Appendix A – Consultation Record

407 TRANSITWAY – WEST OF HURONTARIO STREET TO EAST OF HIGHWAY 400

MINISTRY OF TRANSPORTATION - CENTRAL REGION

Express Toll Route (Toll road)
407
F3
11
Derryerest Dr
© 2017 Goo

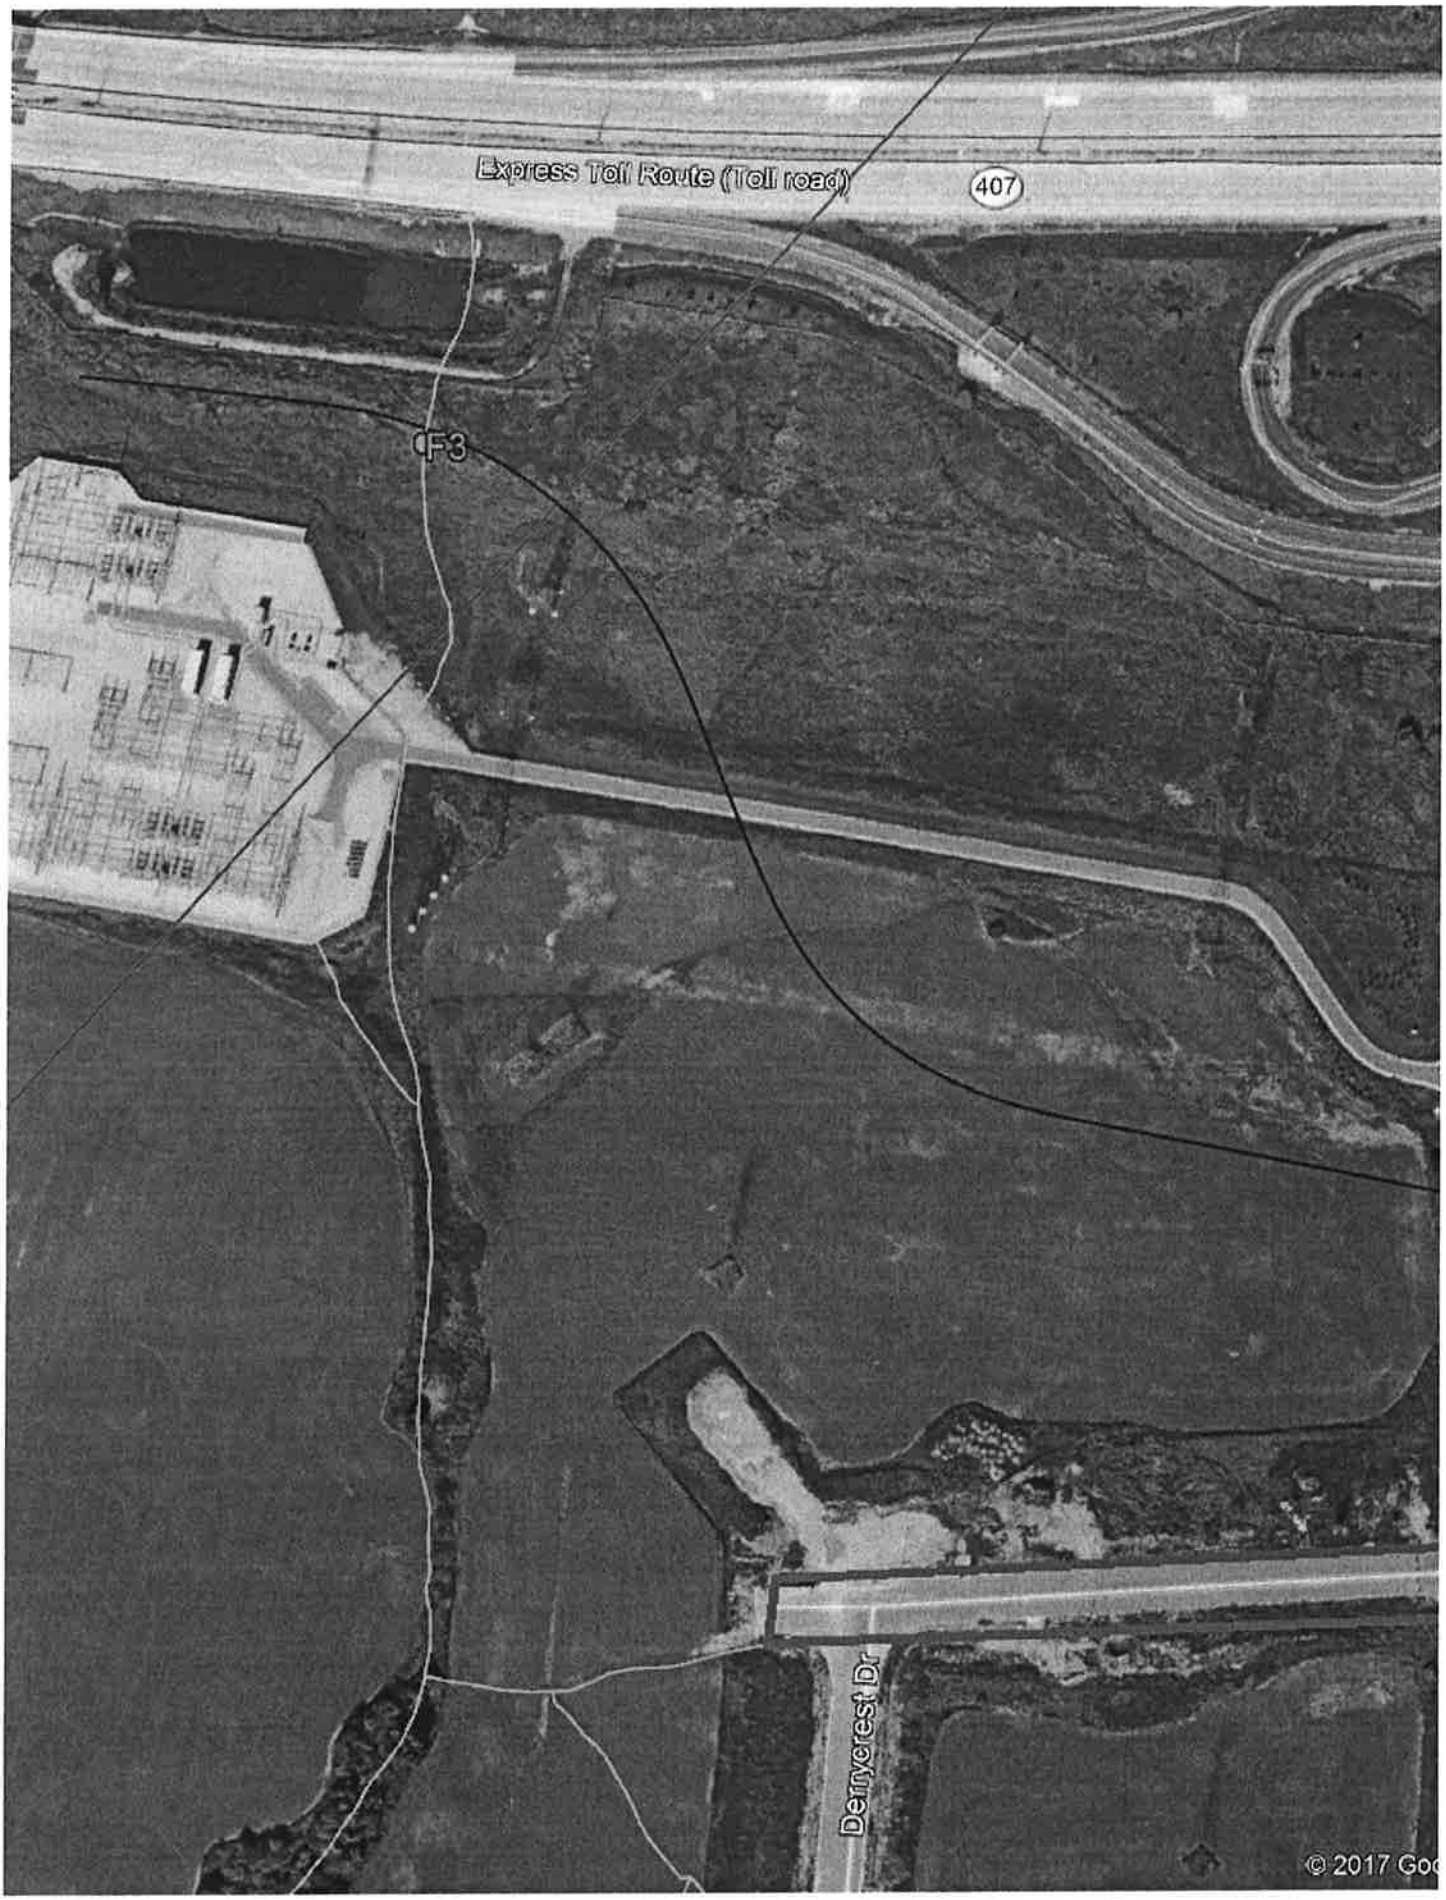
- **Hurontario Street** between the 407 and Derrycrest Drive (refer to Figure 1)
- **Derrycrest Drive** (refer to Figure 1)
- **Highway 410** between the 407 and Derry Road East (refer to Figure 2)
- **Gana Court** (refer to Figure 2)
- **Tomken Road** between Gana Court and the 407 (refer to Figure 2)

Figure 2 - Screenshot of Drawing Showing the Existing 2.4m x 1.2m Culvert

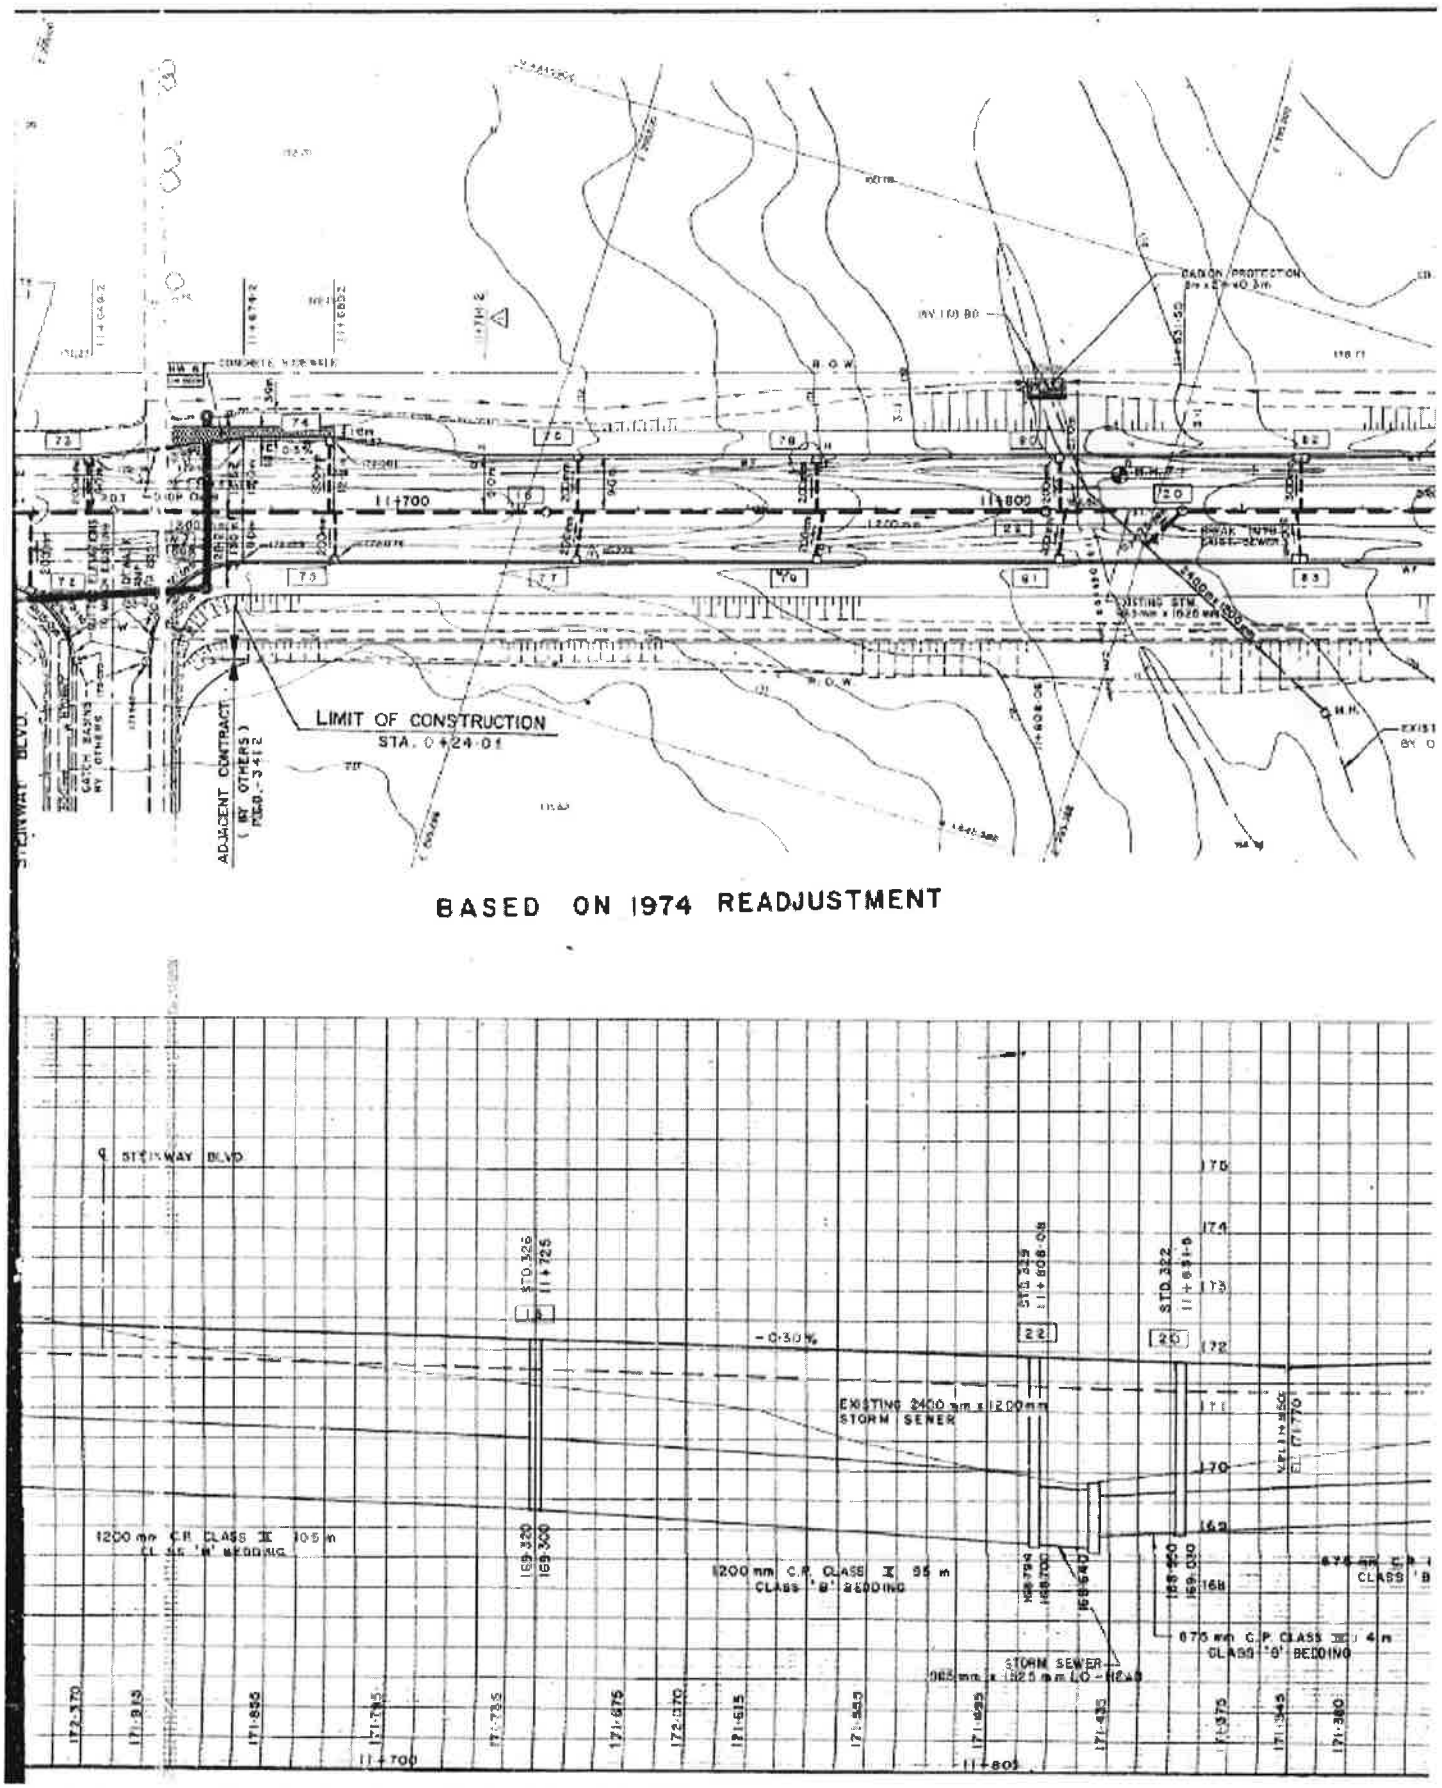
watercourse continues downstream. Figure 2 below shows a screenshot of the drawing which was provided to us, with the existing culvert highlighted.
